DRAFT HERITAGE RECOMMENDATIONS:

FITZROY & COLLINGWOOD PERMANENT DDO CONTROLS

PREPARED FOR: City of Yarra
DATE: 22 November 2022 – DRAFT R2
FILE: 2022-064

Figure 5. Extent of proposed DDO29 – Brunswick Street Shops south of Greeves Street, Fitzroy showing street wall and building heights. ('Map 2' from proposed DDO29)

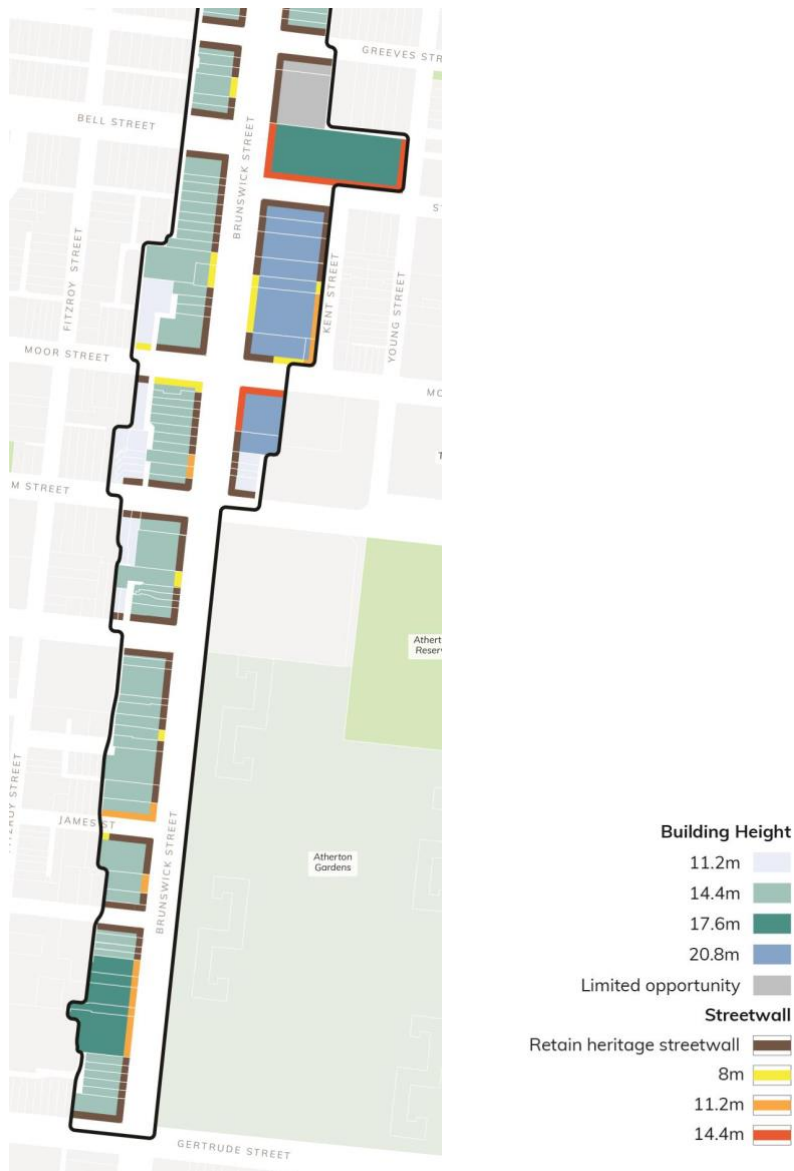
<p><u>Front setback along Brunswick Street</u> Development should achieve a continuous street wall</p>	<p><u>Front setback (infill development)</u> 0m (mandatory)</p>	<p>As there is no precedent for street wall setback on Brunswick Street, we recommend a mandatory 0m front setback and not discretionary (in DDO29 replace the word “should” with “must” here to reflect this).</p>
Upper-Level Front and Side Setback Requirements	<p><u>Minimum setbacks above Brunswick Street street wall</u> 8m (mandatory)</p> <p><u>Minimum setbacks above Johnston Street street wall</u> 6m (mandatory)</p>	<p><u>Minimum setbacks above street wall (Brunswick Street, Johnston Street and Gertrude Street)</u> 8m (mandatory)</p>	<p>We recommend that the 8m upper-level setback to the four corner properties addressing Johnston Street be retained to maintain the prominence of the strong return façades of local landmark buildings that address this important corner.</p>

Built form control type	Proposed DDO29	Recommended built form controls included in the <i>Brunswick and Smith Street Built Form Review: Heritage Analysis & Recommendations</i> (GJM, 2019)	GJM recommended changes to proposed DDO29 [recommendations bolded]
	<p>11.2m (3 storeys) to 14.4m (4 storeys)</p> <p><u>Brunswick Street - at the intersections at Johnston Street and Gertrude Street</u></p> <p>11.2m (3 storeys) to 14.4m (4 storeys)</p> <p>A parcel of land between Greeves and St David streets (on the eastern side of Brunswick Street) is shown as 'limited opportunity' on Map 2 (Figure 5). The shops located here, 236-252 Brunswick Street, are included in the Victorian Heritage Register (H0559).</p>		<p>Victoria Street intersection)</p> <ul style="list-style-type: none"> • 280-284 & 286 Brunswick Street (eastern side, north of Victoria Street) • 196-226 Brunswick Street (inclusive; eastern side, between St David and Moor streets) • 184-186 & 188 Brunswick Street (western side, south of St David Street)

Figure 7. Extent of proposed DDO30 – Smith Street Shops south of Stanley and Moor streets, showing street wall and building heights. ('Map 2' from proposed DDO30)

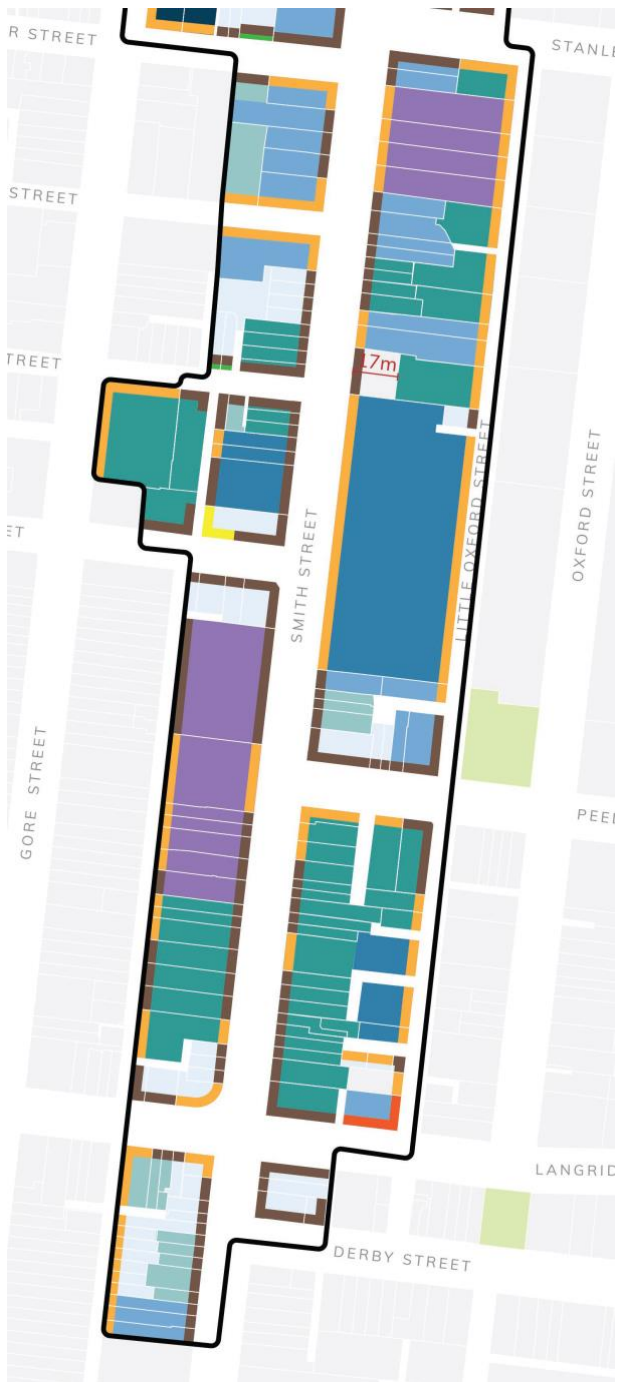
<p><u>Front setback along Smith Street</u> 0m, should achieve a continuous street wall.</p>	<p><u>Front setback (infill development)</u> 0m (mandatory)</p>	<p>As there is no precedent for street wall setback on Smith Street, we recommend a mandatory 0m front setback and not discretionary (in DDO30 replace the word “should” with “must” here to reflect this).</p>
<p>Upper-Level Setback Requirements</p>	<p><u>Minimum setbacks above Smith Street street wall</u> 8m (mandatory)</p> <p><u>Minimum setbacks above Johnston Street street wall</u> 6m (mandatory)</p>	<p><u>Minimum setbacks above street wall (Smith Street, Johnston Street and Gertrude Street)</u> 8m (mandatory)</p> <p><u>Minimum setbacks above street wall (side streets other</u></p>	<p>No changes recommended. Although we previously recommended the 8m upper-level setback on Johnston Street be retained, this intersection is substantially less intact than at the Brunswick and Johnston streets</p>

Figure 18. Extent of proposed DDO37 – Smith Street North and South, south of Derby Street, showing street wall and building heights. ('Map 2' from proposed DDO37)

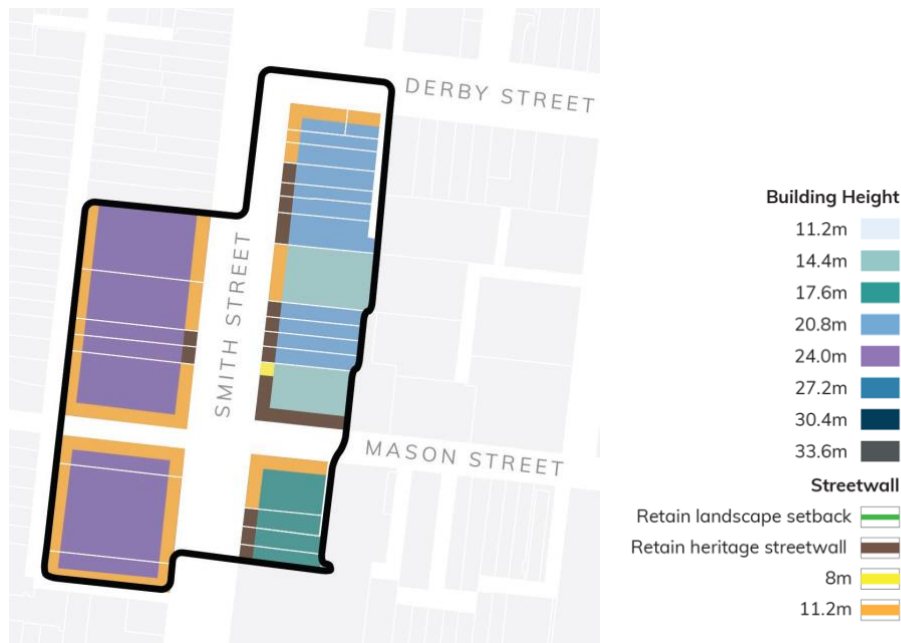
Built form control type	Proposed DDO37	Recommended built form controls included in the <i>Brunswick and Smith Street Built Form Review: Heritage Analysis & Recommendations</i> (GJM, 2019)	GJM recommended changes to proposed DDO37 [recommendations bolded]
<p>Street Wall Height and Setback Requirements</p>	<p>Street wall heights should not exceed the heights specified in Maps 1 and 2 (Figures 17 and 18, above), as applicable.</p> <p>The maximum street wall height ranges from 8m to 11.2m where ‘retain heritage streetwall’ is not specified.</p> <p>‘Retain landscape setback’ applies to small sections of Mater and Kerr streets.</p> <p><u>Street wall height (infill development)</u></p> <p>Must match the frontage street wall height of an adjoining heritage property for a minimum length of 6m along the front boundary.</p> <p><u>Street wall height on corner buildings</u></p> <p>Should continue the main frontage street wall height for a minimum of 8m to the side street, with a transition in height to match the rear interface where required.</p>	<p><u>Maximum street wall height (infill development)</u></p> <p>11m (mandatory)</p> <p><u>Minimum street wall height (infill development)</u></p> <p>8m (mandatory)</p> <p><u>Street wall height (infill development)</u></p> <p>Match the parapet height of the adjacent taller heritage building (preferred)</p>	<p>No changes recommended.</p> <p>We note that the proposed DDO does not stipulate a minimum street wall height, as recommended by GJM. However, the requirement for new development to match the wall height of the adjoining heritage property for a minimum length of 6m along the front boundary we believe will, at least in part, address this.</p>

Built form control type	Proposed DDO37	Recommended built form controls included in the <i>Brunswick and Smith Street Built Form Review: Heritage Analysis & Recommendations</i> (GJM, 2019)	GJM recommended changes to proposed DDO37 [recommendations bolded]
	<p><u>Smith Street front setback</u> Development should achieve a continuous street wall with no front setback</p>	<p><u>Front setback (infill development)</u> 0m (mandatory)</p>	<p>As there is no precedent for a street wall setback on Smith Street, we recommend a mandatory 0m front setback and not discretionary (in DDO37 replace the word “should” with “must” here to reflect this).</p>
Upper-Level Setback Requirements	<p><u>Minimum upper-level setbacks above Smith Street street wall where the Heritage Overlay applies</u> 8m (mandatory)</p> <p><u>Minimum upper level setbacks above Smith Street street wall where no Heritage Overlay applies</u> 8m (discretionary)</p> <p><u>Minimum setbacks above side street street wall</u> 6m (discretionary)</p> <p><u>Development greater than 16.4m storeys above a heritage building</u> The topmost upper level of development over 16.4m should be set back a further 3.2m from the Smith Street frontage.</p>	<p><u>Minimum setbacks above Smith Street street wall</u> 8m (mandatory)</p> <p><u>Minimum setbacks above side streets street wall</u> 6m (preferred)</p> <p><u>Minimum upper-level setbacks</u> As defined by a 45° angular plane drawn from the maximum street wall height (11m) (preferred)</p>	<p>No changes recommended. Following the consideration of angular plane or sightline tests in Amendments C220yara and C191yara, we consider the additional 3.2m upper-level setback above 16.4m more appropriately achieves a satisfactory heritage outcome. This is consistent with Amendments C293yara and C291yara, where the sightline test was removed from the interim DDO23 (that applies to the Collingwood South Mixed Use Precinct), interim DDO21 (Bridge Road) and interim DDO22 (Victoria Street). This has been replaced with specified upper-level setbacks in the Council adopted Amendment C293yara and C291yara DDO controls.</p>

Overall Building Height Requirements	<p>Development should not exceed the heights as shown on Maps 1 and 2 (Figures 17 and 18, above), as applicable.</p> <p>Smith Street North <u>East side of Smith Street</u> 20.8m (6 storeys) to 30.4m (9 storeys) (discretionary)</p> <p><u>Cecil Street at rear of Smith Street facing properties</u></p>	<p>Smith Street North <u>Between Westgarth and Mater Streets and Kerr and Hotham Streets</u> 5 to 9 storeys (mandatory)</p> <p>Smith Street South <u>East side of Smith Street, south of Derby Street</u> 4-6 storeys (mandatory)</p>	<p>No changes recommended. The proposed DDO applies maximum building heights within the ranges recommended by GJM, however these are applied as discretionary rather than mandatory provisions. Given the larger site, emerging and existing development and less consistent street wall within these sub precincts, the flexibility provided by a</p>

Figure 23. Extent of proposed DDO40 – Fitzroy West, showing street wall and building heights. ('Map 1' from proposed DDO40)

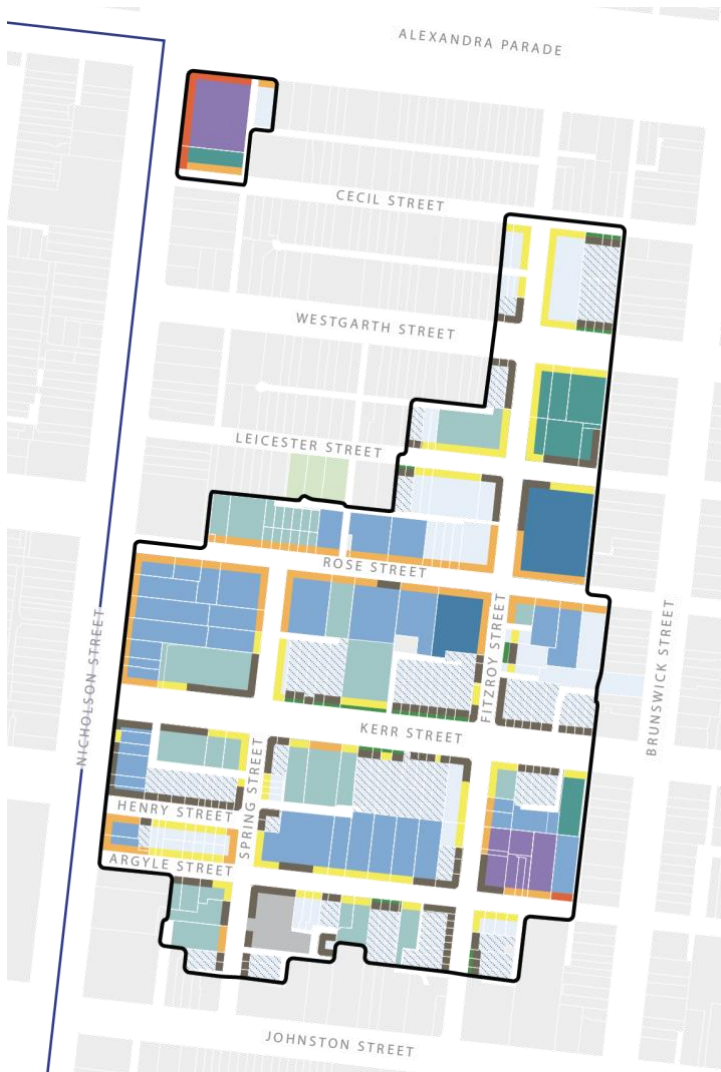
Built form control type	Proposed DDO40	Recommended built form controls included in the <i>Built Form Review: Fitzroy West Mixed Use Precinct Heritage Analysis & Recommendations</i> (GJM, 2020)	GJM recommended changes to proposed DDO40 [recommendations bolded]
Street Wall Height and Setback Requirements	<p>Street wall heights should not exceed the heights specified in Map 1 (Figure 23, above), as applicable.</p> <p>The maximum street wall height ranges from 8m to 16m where ‘retain heritage streetwall’ is not specified.</p> <p>‘Retain landscape setback’ applies to Cecil, Westgarth, Kerr and Fitzroy streets where these exist in front of the heritage street wall.</p> <p><u>Street wall height (infill development)</u></p>	<p><u>Maximum street wall height (infill development) within or immediately adjacent to land subject to the Heritage Overlay</u></p> <p>Match the parapet height of the adjacent heritage building to the width of the property boundary or for a distance of 6m, whichever is less.</p> <p>(preferred)</p>	No changes recommended.

Built form control type	Proposed DDO40	Recommended built form controls included in the <i>Built Form Review: Fitzroy West Mixed Use Precinct Heritage Analysis & Recommendations</i> (GJM, 2020)	GJM recommended changes to proposed DDO40 [recommendations bolded]
	<p><u>Spring streets and Argyle and Fitzroy streets</u> 6m (discretionary)</p> <p><u>Minimum setbacks above the street frontage of Rose Street, Fitzroy Street, Spring Street (where north of Kerr Street) and Henry Street</u> 3m (discretionary)</p> <p><u>Development greater than 16.4m</u> A further 3.2m for the topmost upper level above a heritage building from the principal frontage. (discretionary)</p> <p><u>Upper levels above a secondary street wall of a heritage building on corner sites</u> 6m (discretionary)</p>		<p>satisfactory heritage outcome. This is consistent with Amendments C293yara and C291yara, where the sightline test was removed from the interim DDO23 (that applies to the Collingwood South Mixed Use Precinct), interim DDO21 (Bridge Road) and interim DDO22 (Victoria Street). This has been replaced with specified upper-level setbacks in the Council adopted Amendment C293yara and C291yara DDO controls.</p>

<p>Overall Building Height Requirements</p>	<p>Development on sites shown as 'Victorian Terraces' (hatched on Map 1 [Figure 23, above]) must not exceed 11m (3 storeys). All other development should not exceed the heights shown on Map 1, as applicable.</p> <p>The Former Cordial Factory, 8-12 Spring Street and 14-16 Argyle Street, Fitzroy (VHR H2257) is shown as 'limited opportunity'</p> <p><u>Mixed Use Precinct of Fitzroy West</u> 11.2m (3 storeys) to 27.2m (8 storeys)</p>	<p><u>Commercial and industrial buildings within the Heritage Overlay</u> 14m (4 storeys) to 24m (7 storeys), depending on the depth of the block, neighbouring built form and context (preferred)</p> <p><u>Residential buildings within the Heritage Overlay</u> 11m (3 storeys) (mandatory)</p>	<p>No changes recommended.</p>
